Addendum No. 2

Rock River Water Reclamation District Cherry Valley Lift Station – Pump 2 and Pump 3 Replacement Capital Project No. 1911

This Addendum No. 2, dated August 30, 2019, for the above-referenced project, supersedes all contrary and conflicting information in the project specifications and contract documents, which are hereby supplemented or revised as follows:

MECHANICAL
REPLACEMENT PLAN

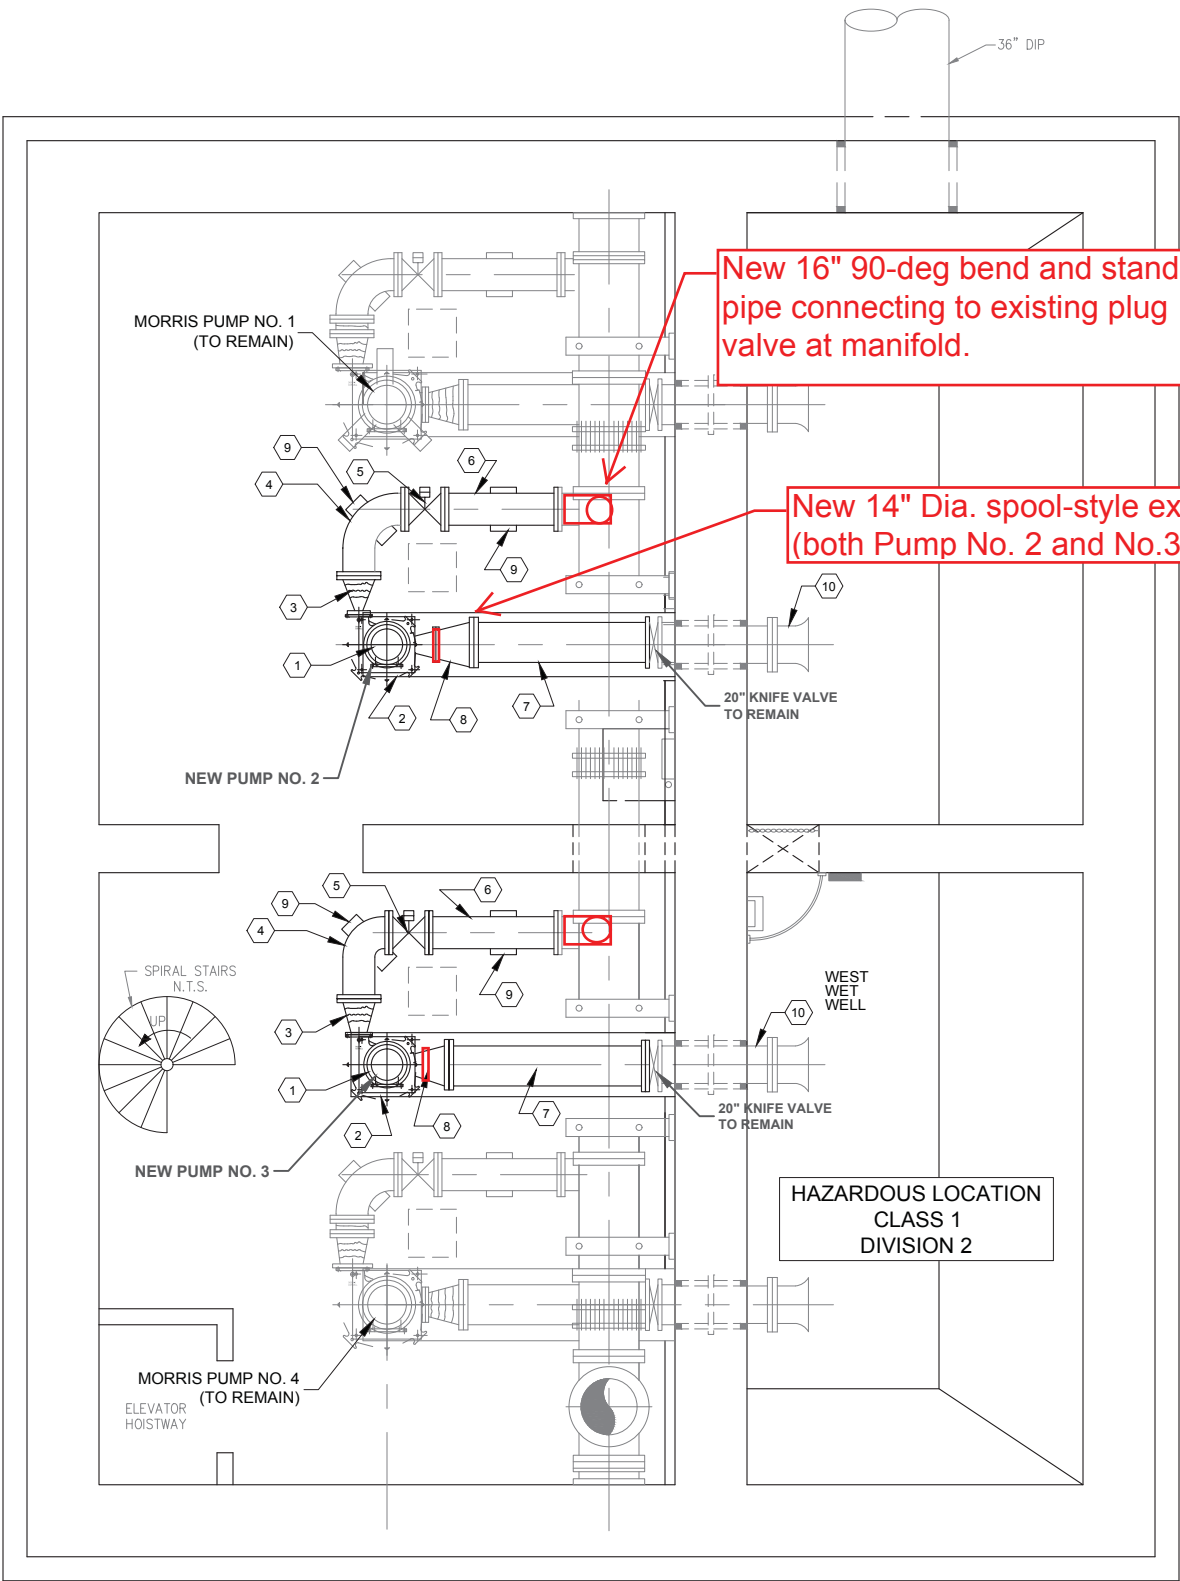
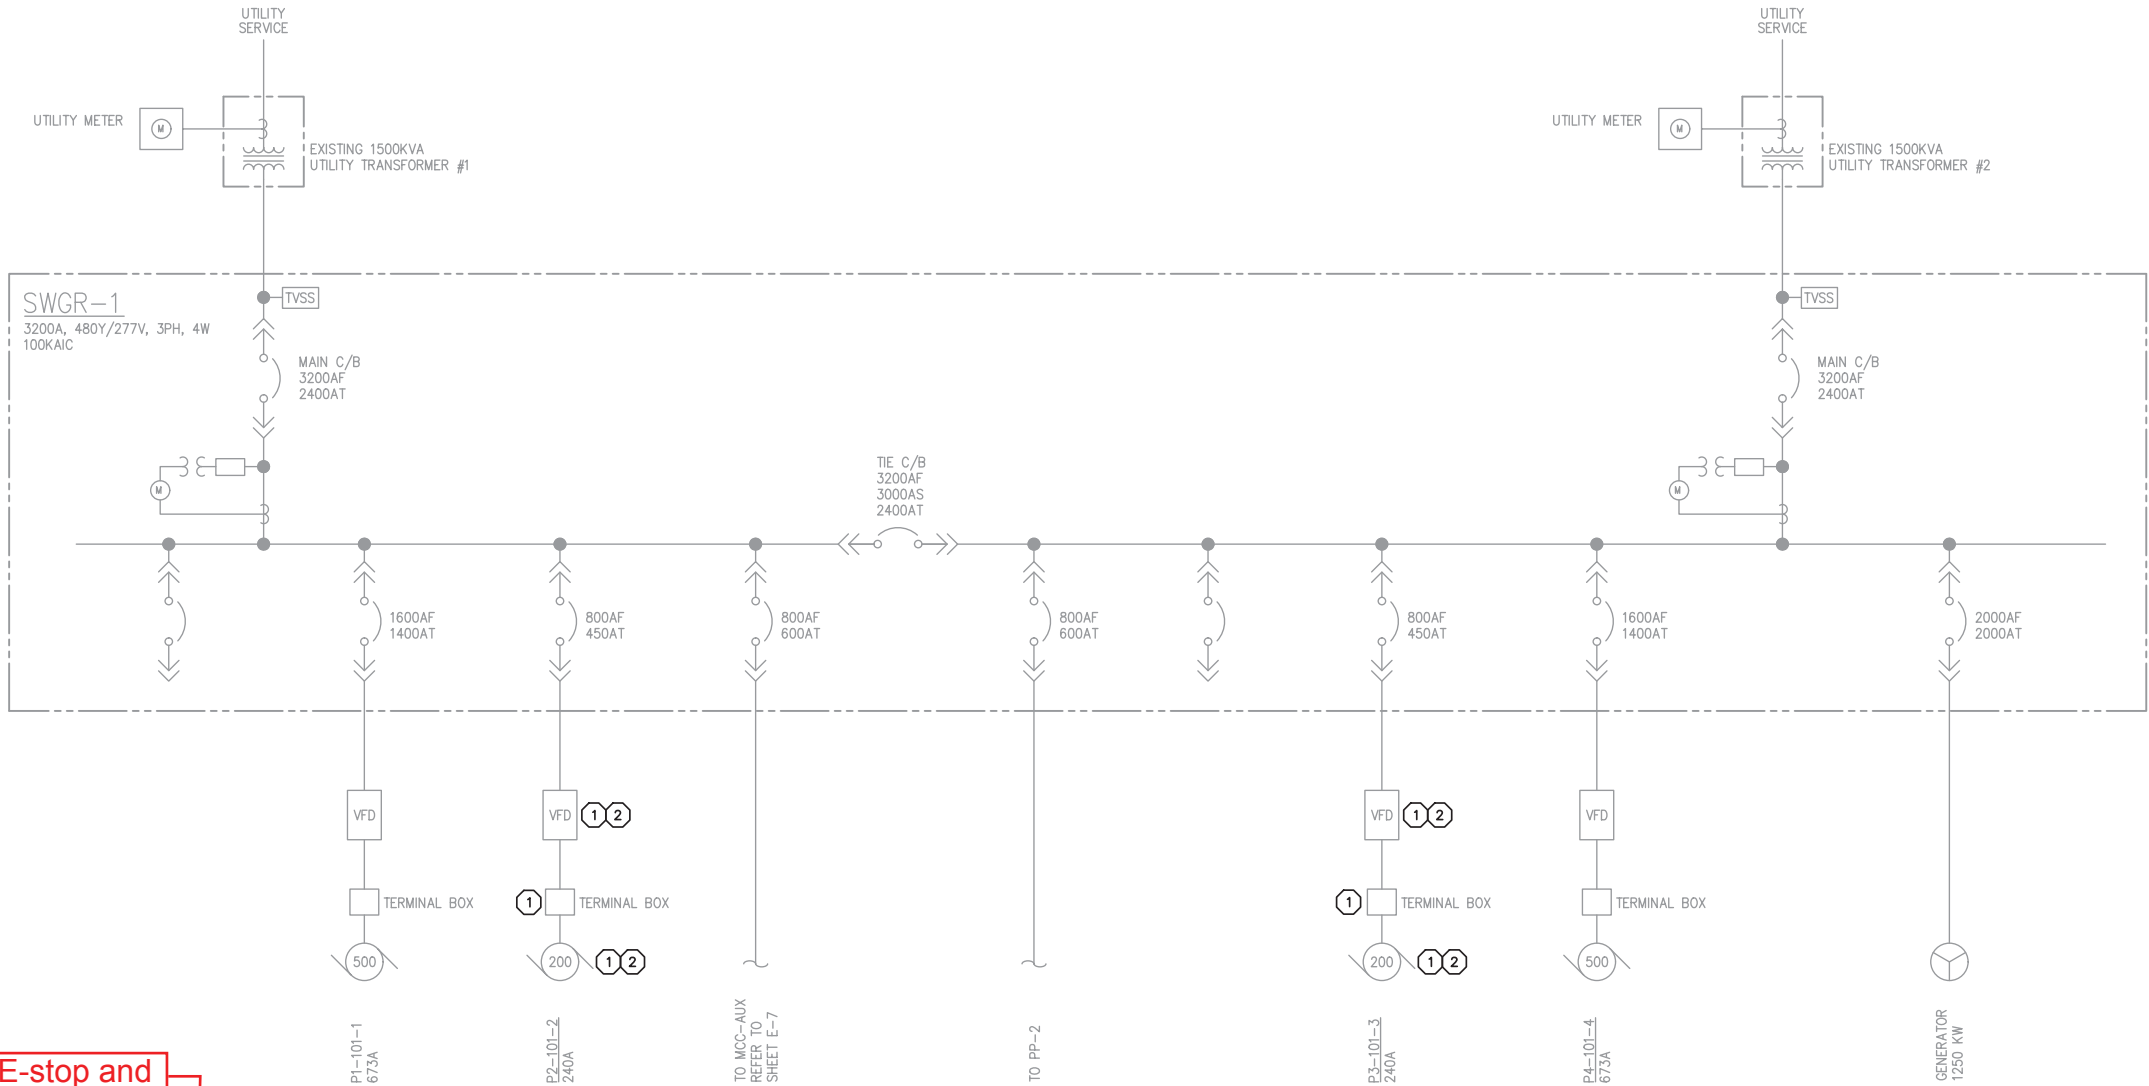
- NEW PUMP BASES (SEE STRUCTURAL SHEET 99-S-1)
- NEW 16"x12" FLEXIBLE ~~ECCENTRIC~~ REDUCER
- NEW 16" PIPE ELBOW
- NEW 16" OPERATED CYLINDER ECCENTRIC PLUG VALVE

- NEW 16" DUCTILE IRON PIPE
- NEW 20" DUCTILE IRON PIPE
- NEW 20"x14" ECCENTRIC REDUCER
- NEW CONCRETE PIPE SUPPORTS (SEE STRUCTURAL SHEET 99-S-1)
- REMOVE DEBRIS FROM EXISTING 20" KNIFE VALVE TO END OF SUCTION LINE IN WET WELL. COORDINATE WITH OWNER, ACCESS TO THE WET WELL TO CLEAN THE 20" SUCTION LINE BY JETTING THE LINE. THE DEBRIS MAY BE LEFT IN THE WET WELL. EXCESS DEBRIS NEAR SUCTION LINE SHALL BE DISPERSED TO PREVENT INFLUX OF CONCENTRATED SOLIDS INTO PUMP DURING START-UP.

Total pipe supports - 3 per pump.
1- on 20" suction piping.
1- on 16" discharge piping (horizontal)
1- on 16" discharge (90-deg bend to vertical piping)
See Sheet 99-S-1 for concrete and reinforcement requirements.

Addendum No. 2, 8/30/2019 revisions in red.

30-ER-1

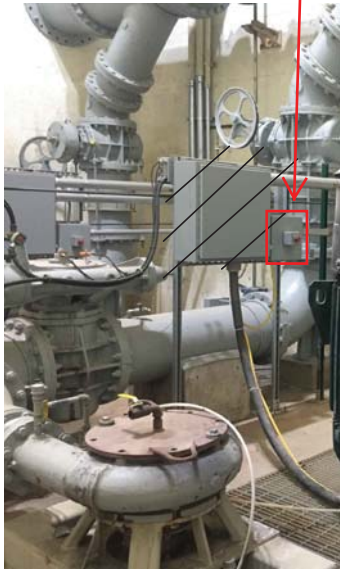
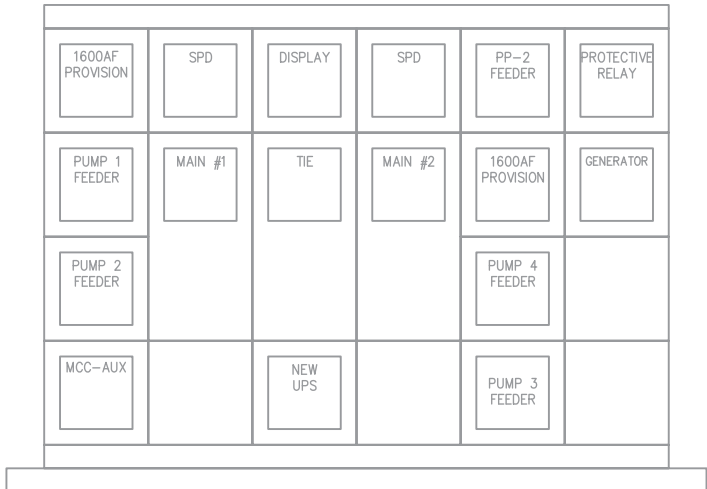
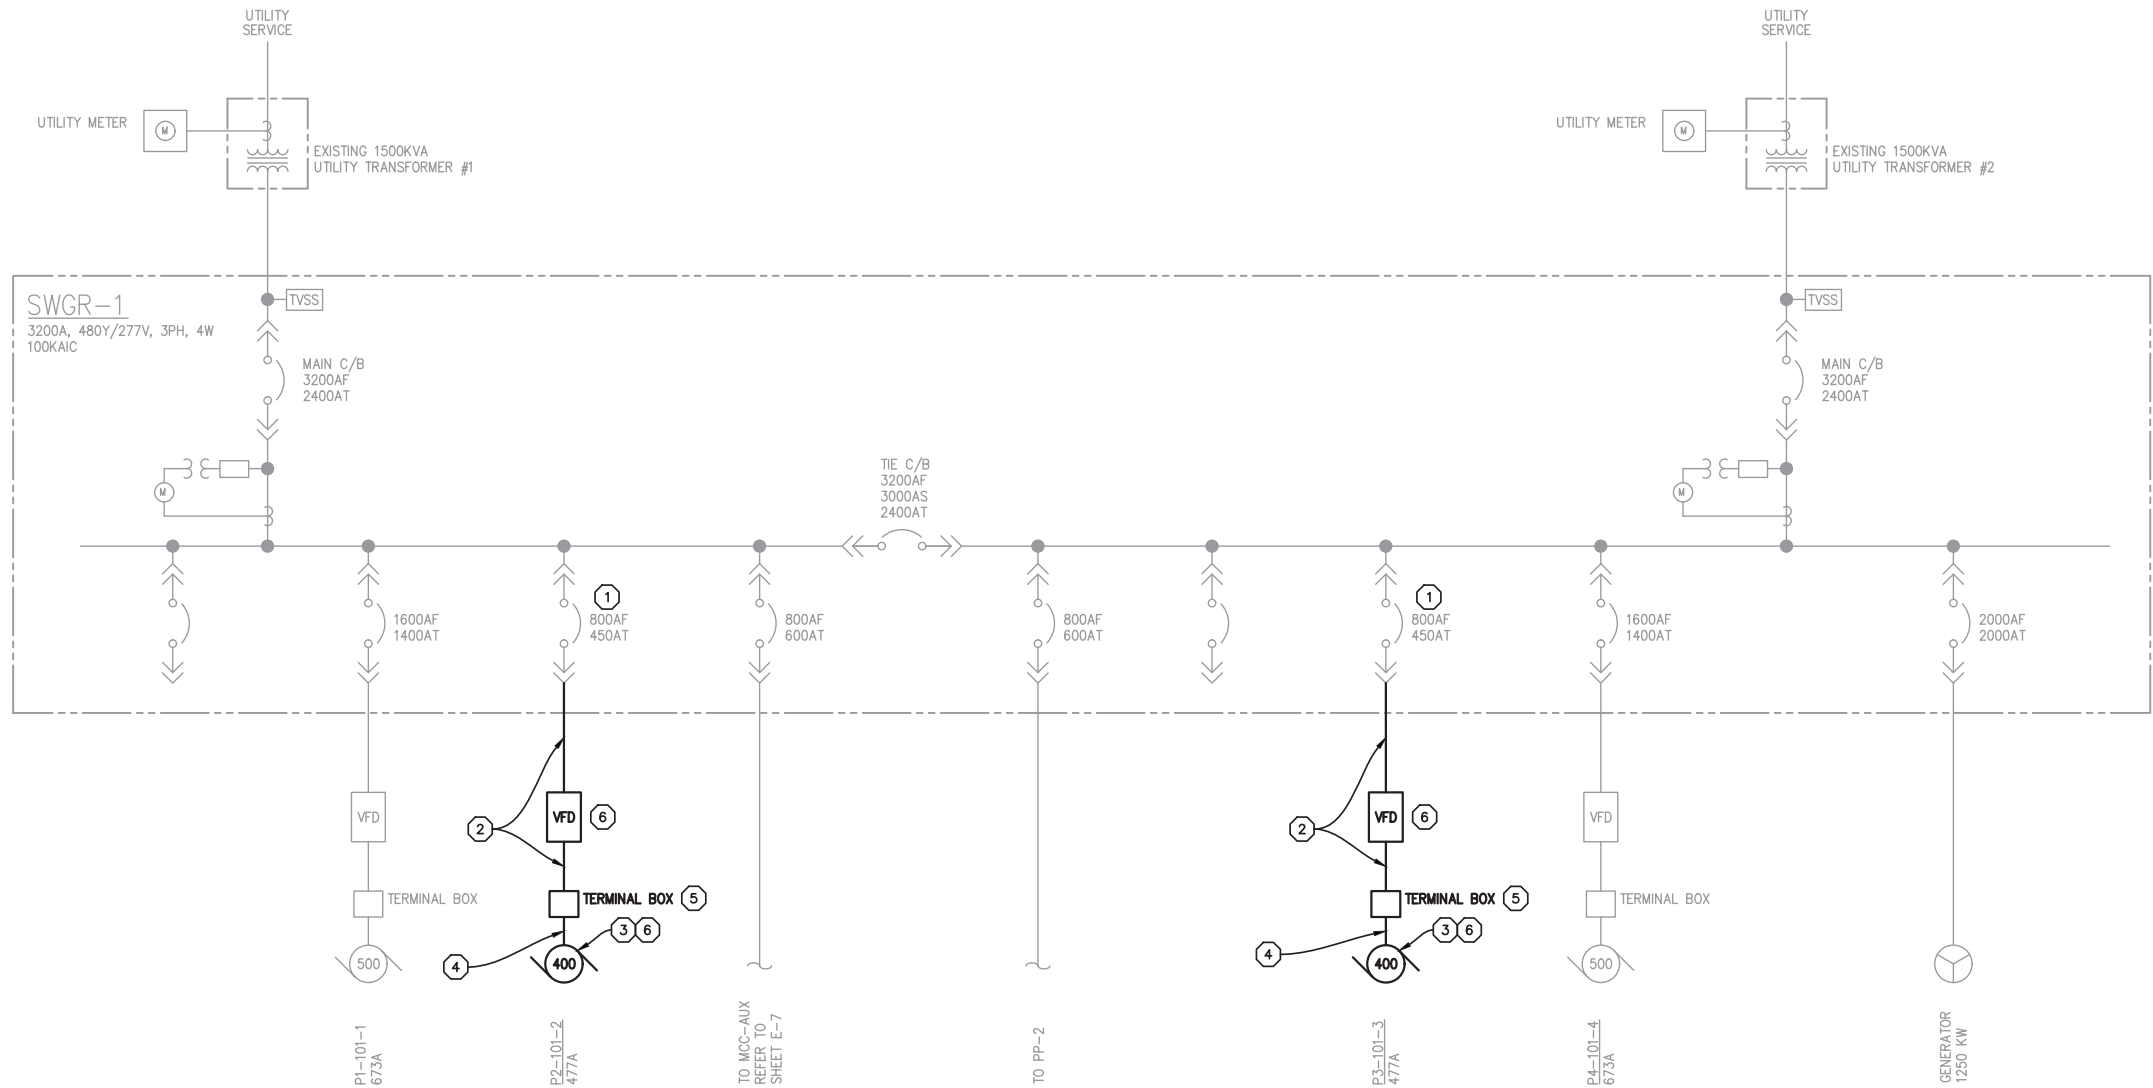
4. Sheet 30-ER-1: Revised Sheet 30-ER-1 is attached.
 - a. Key Note #1 Clarification: The only item the RRWRD will salvage during demolition work is the existing pneumatic plug valve and actuator from Pump No. 3. All other items removed in demolition shall be removed and disposed of by the Contractor. Upon removal, the plug valve and actuator may be stored on the main floor level for RRWRD pick up.

DRAWING NO.
30-E-1

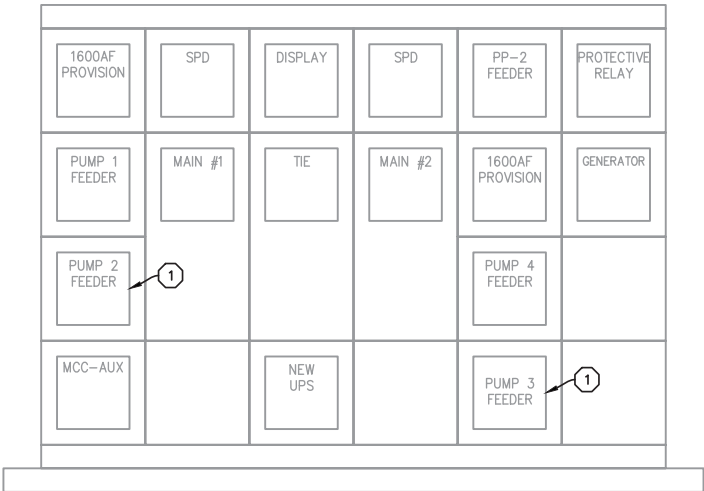
Revise to 3" conduit to EMT.
Contractor may re-use existing
350KCMIL Conductors (1 set of
3 per existing pump).

- 1 REPLACE EXISTING TRIP MODULE WITH NEW 700 AMP UNIT FOR THIS SQUARE-D MASTERPACT BREAKER.
- 2 PROVIDE 2[(3)350KCMIL, #1/0G, 3" ~~ORS~~ CONDUIT]. AN EMPTY 3" CONDUIT RUNS PART WAY BETWEEN EACH VFD AND THE EXISTING TERMINAL BOX. CONTRACTOR TO FIELD-VERIFY EXTENT.
- 3 RECONNECT THE FOLLOWING SIGNALS FROM THE NEW PUMP/MOTOR ASSEMBLIES TO THE PLC PANEL:
A. ~~HIGH VIBRATION~~
B. ~~PUMP BEARING HIGH TEMPERATURE~~
C. ~~MOTOR WINDING HIGH TEMPERATURE~~
EXTEND EXISTING CIRCUITS AND CONDUIT, IF NECESSARY.
- 4 PROVIDE 2[(3)350KCMIL, #1/0G, 3" LIQUID-TIGHT CONDUIT].
- 5 SIZE OF REPLACEMENT TERMINAL BOX SHALL MEET N.E.C. REQUIREMENTS.
- 6 RECONNECT EXISTING LOW VOLTAGE SIGNAL AND MONITORING CIRCUITS. REFER TO P&ID SHEET NO. 10 DATED JAN 2011 (CAPITAL PROJECT NO. 1032)
